RECEIPT DATE: 05/02/2019 **ONSITE SEWAGE DISPOSAL SYSTEM**

PROPERTY ADDRESS: 1817 Quarter Horse Drive

From: Oswald, Hank
Sent: Monday, July 09, 2018 10:06 AM
To: 'stephanie@fcc-eng.com'
Subject: OSDS Plan_1817 Quarter Horse Drive

The revised OSDS Plan for 1817 Quarter Horse Drive has been reviewed with the following comments:

SEPTIC INSTALL PLAN
1817 QUARTER HORSE DRIVE
PARCEL: 36
3RD ELECTION DISTRICT
TAX MAP # 10
HOWARD COUNTY, MARYLAND
DATE: SEPT. 13, 2018

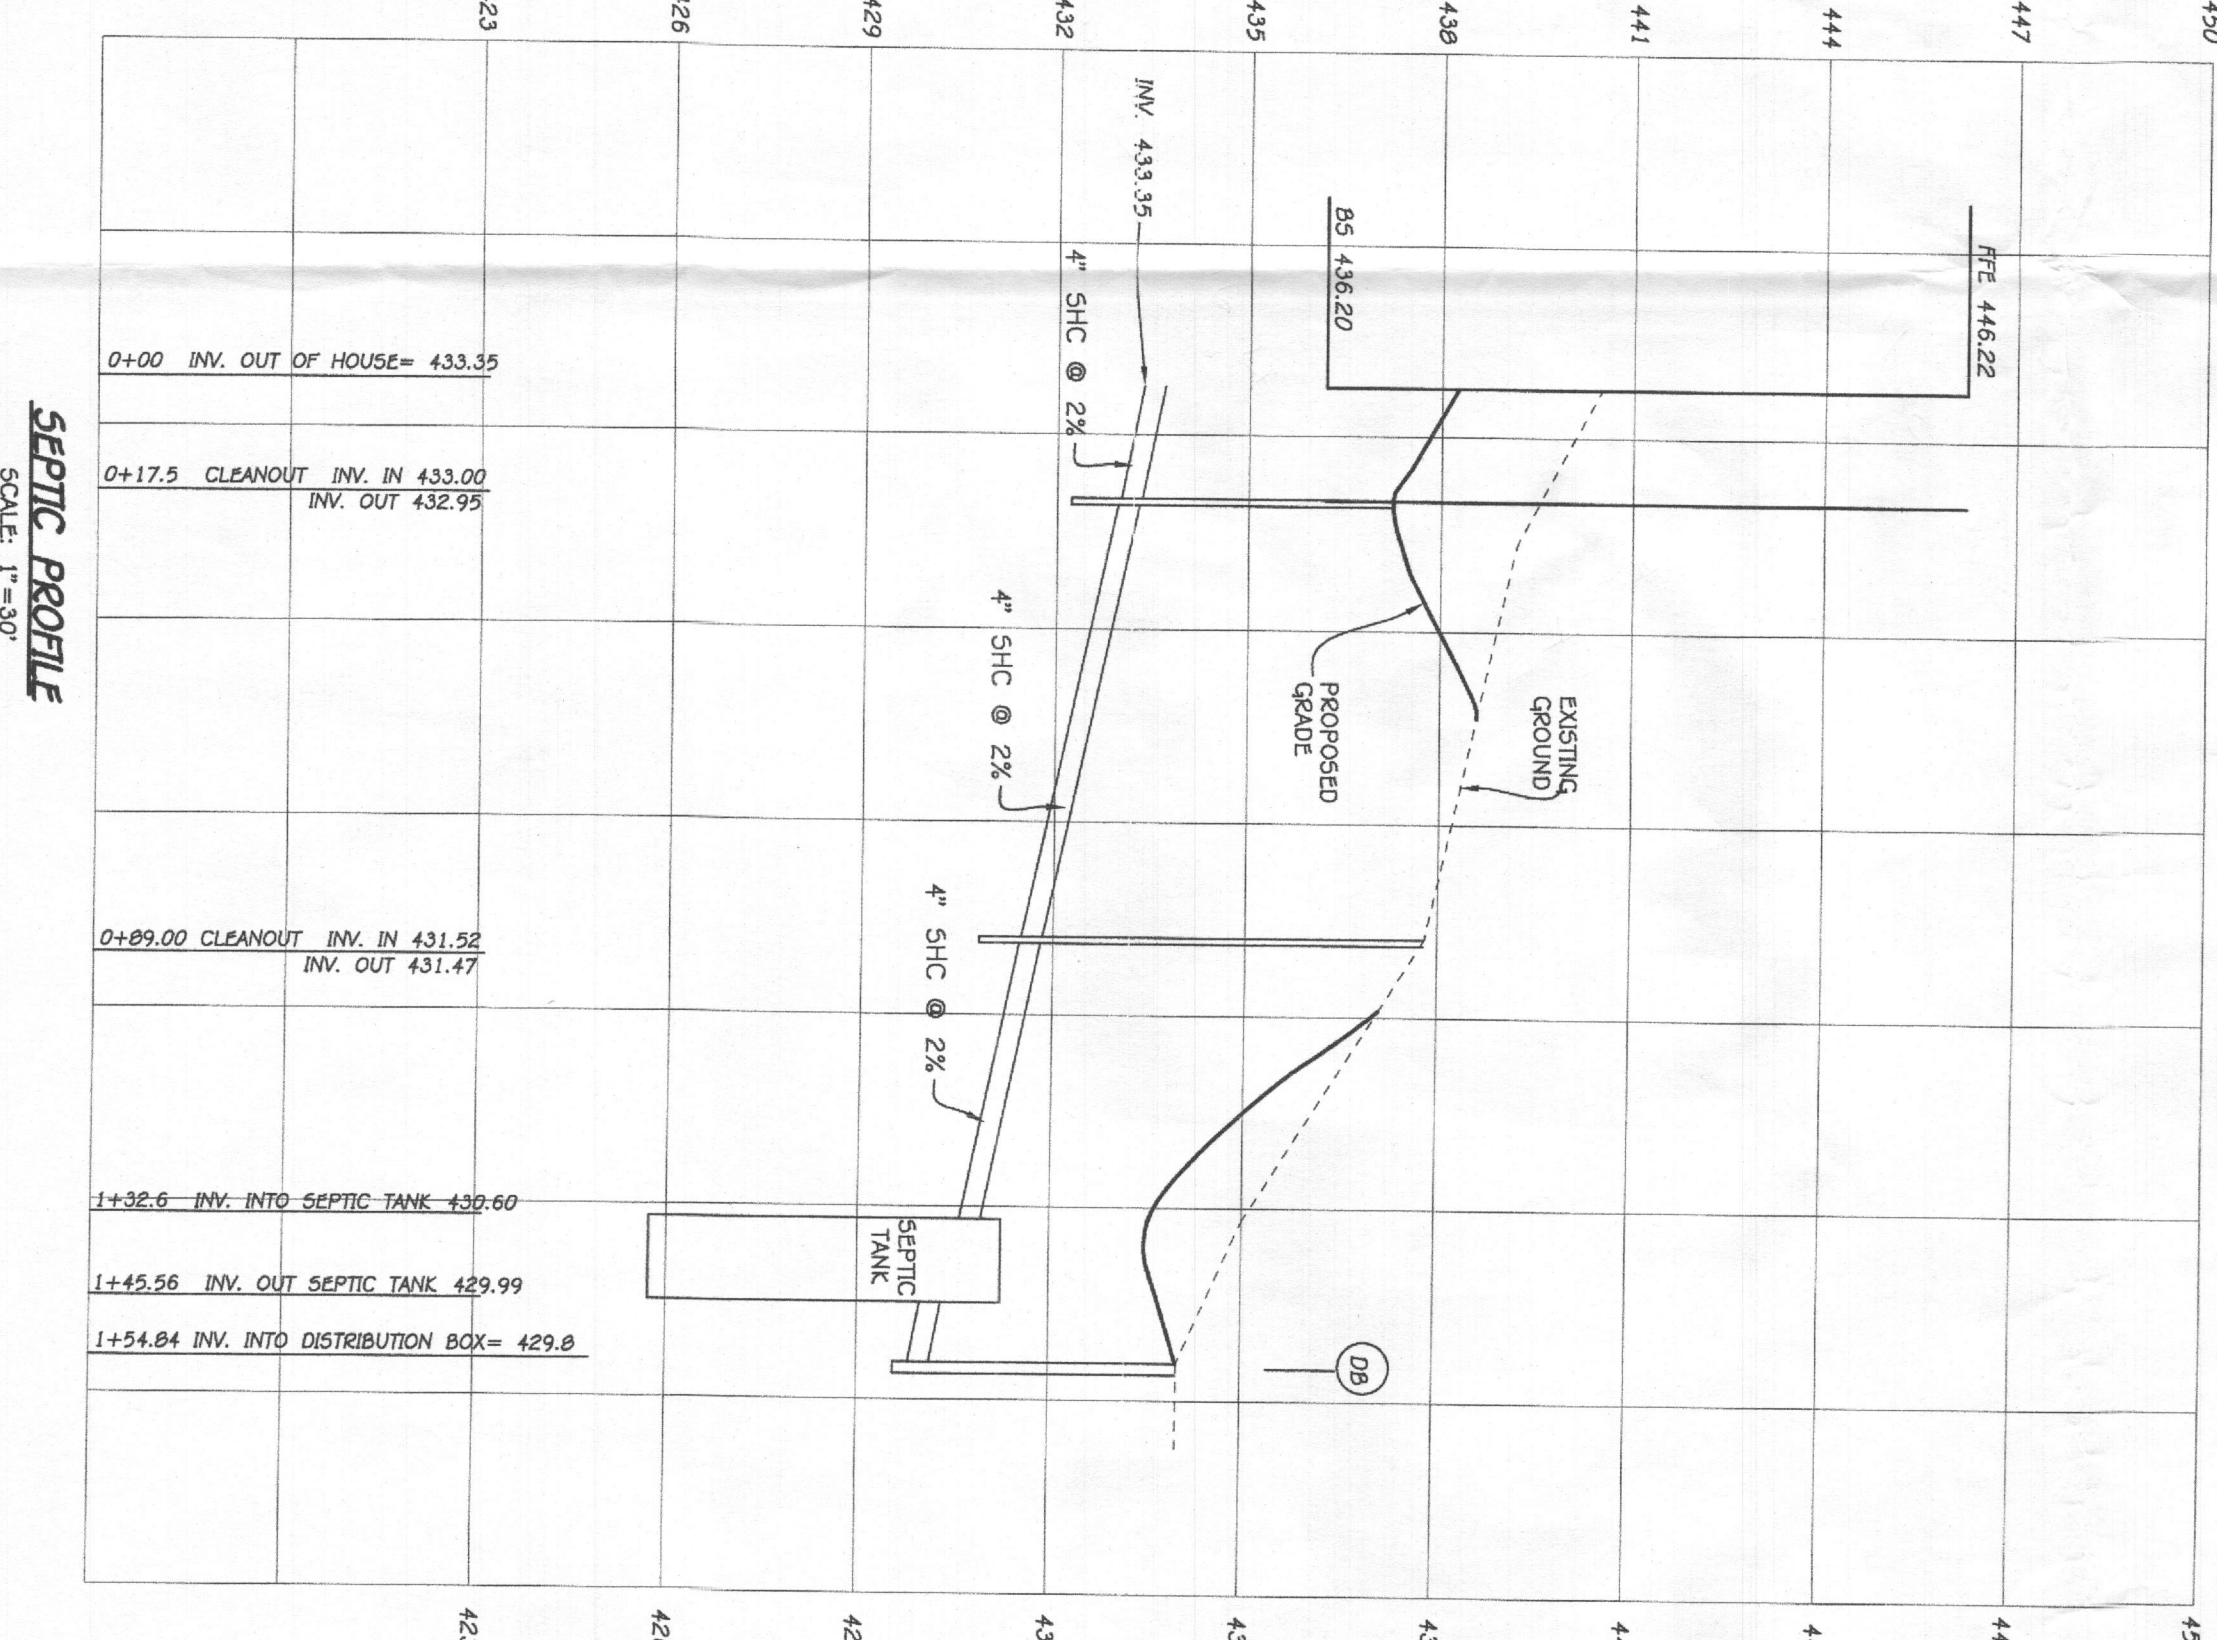
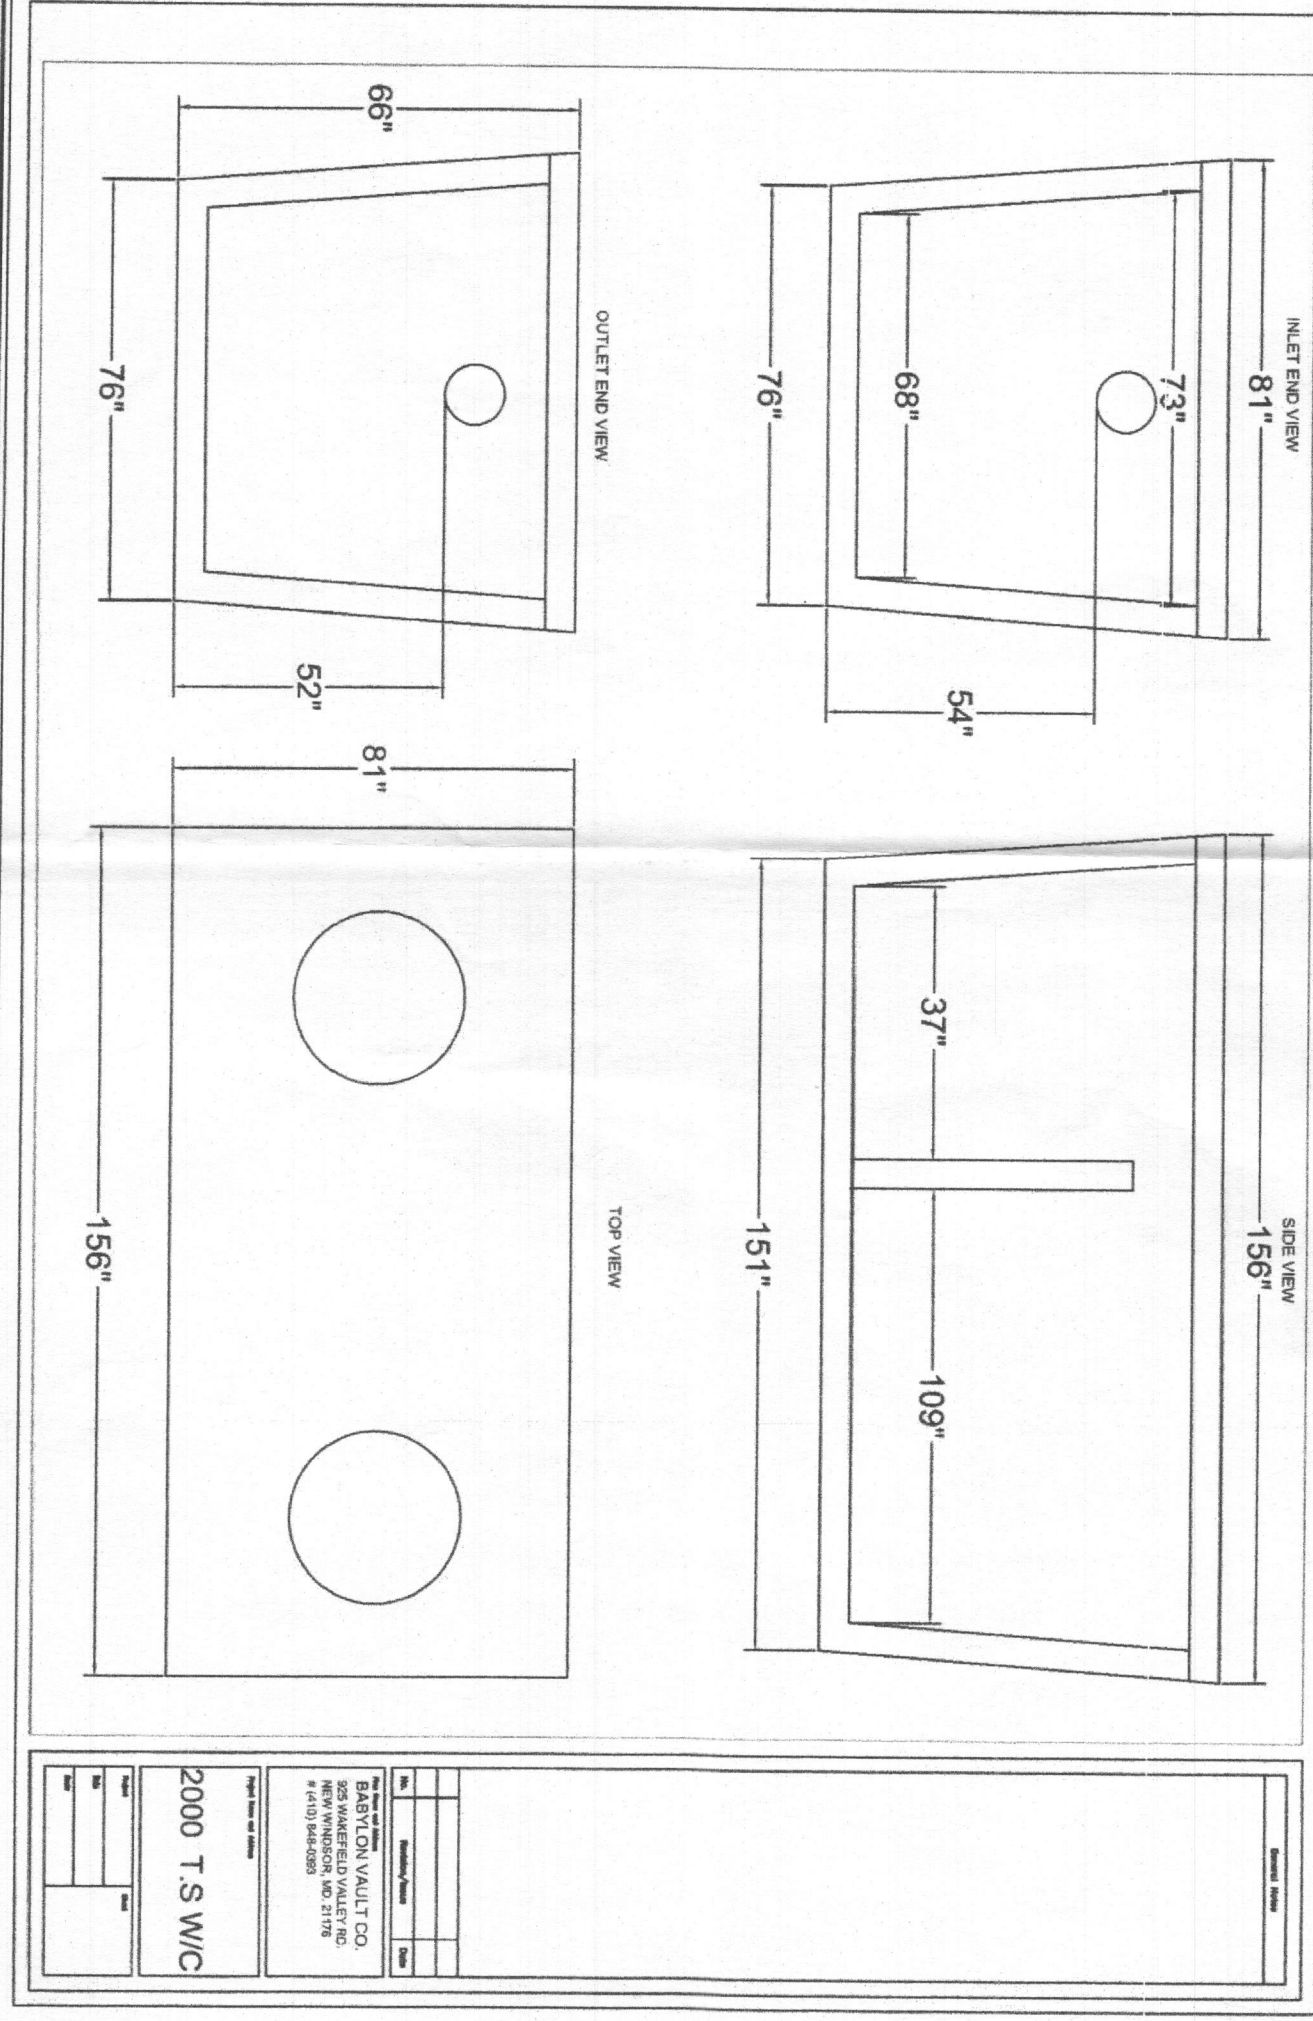
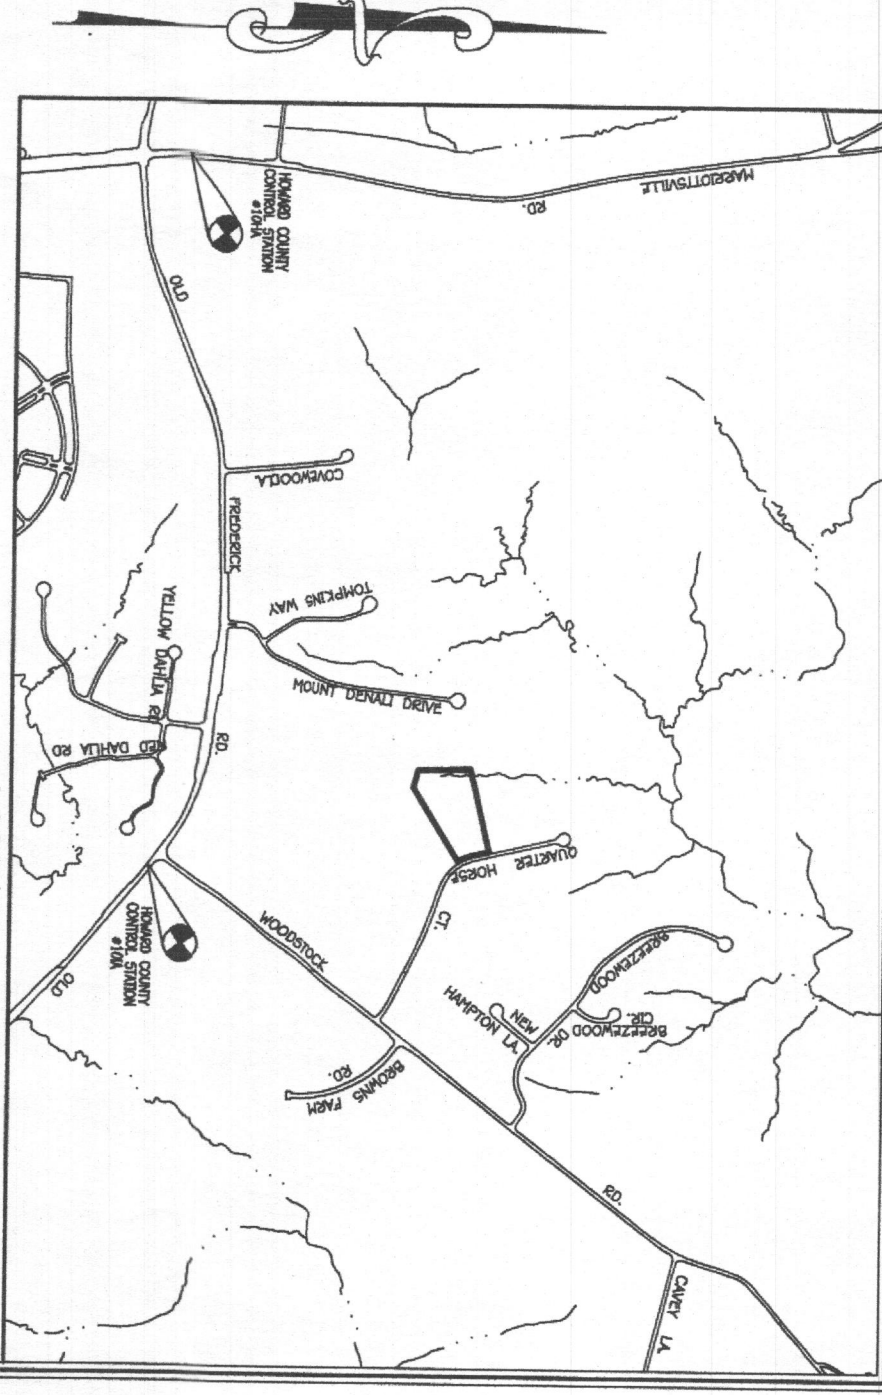
- The length of trench before sidewall reduction credit should be 312.5 (not 250)
- The total length of trench should be 130.31 (not 104.25) for all 3 systems.
- The list of elevations next to calculations still do not completely match the elevations in the septic profile.
- The legend symbol for proposed percs still reads the same. Change it to read, Denotes passed perc tests from 2/21/2018.
